Engineer: P McGill			
Title: Coastal Profiling Float Motherboard: Power Supplies			
Size: C	Document Number: 11021161		Rev: 1.9.0
Date: Wednesday, April 26, 2017	Sheet 2 of 3

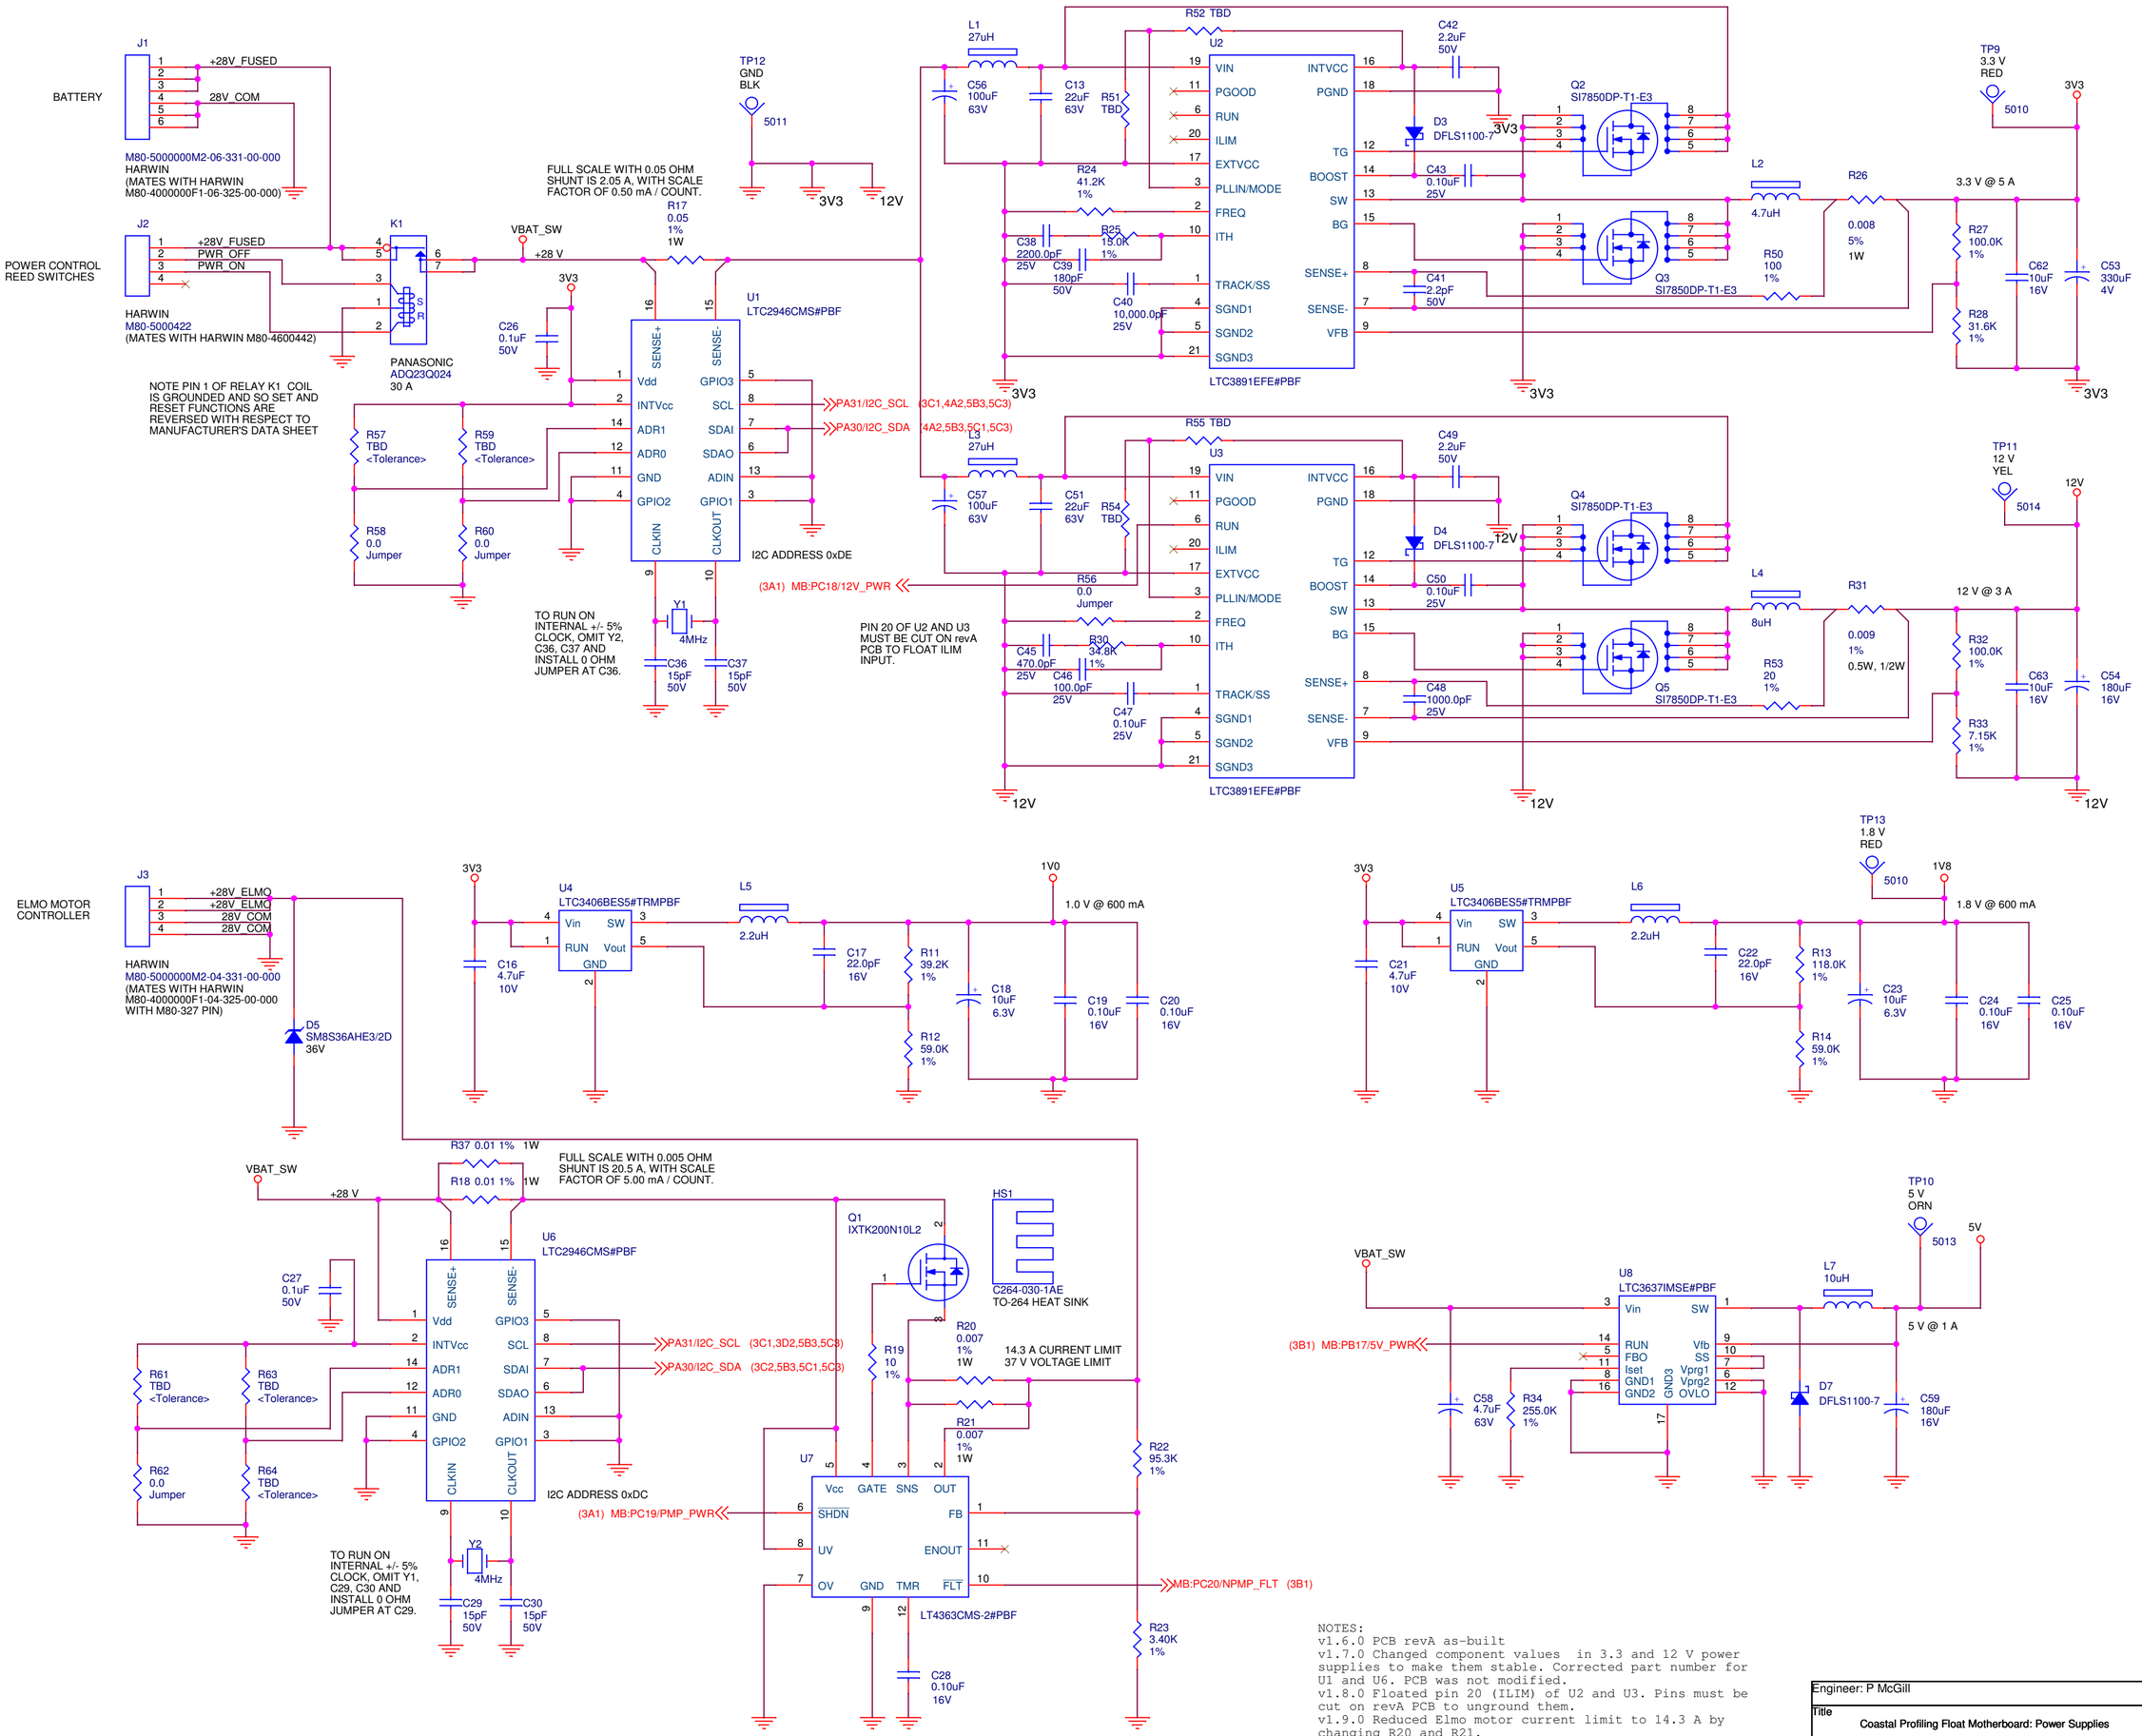
NOTES:
v1.6.0 PCB revA as-built
v1.7.0 Changed component values in 3.3 and 12 V power supplies to make them stable. Corrected part number for U1 and U6. PCB was not modified.
v1.8.0 Floated pin 20 (ILIM) of U2 and U3. Pins must be cut on revA PCB to unground them.
v1.9.0 Reduced Elmo motor current limit to 14.3 A by changing R20 and R21.
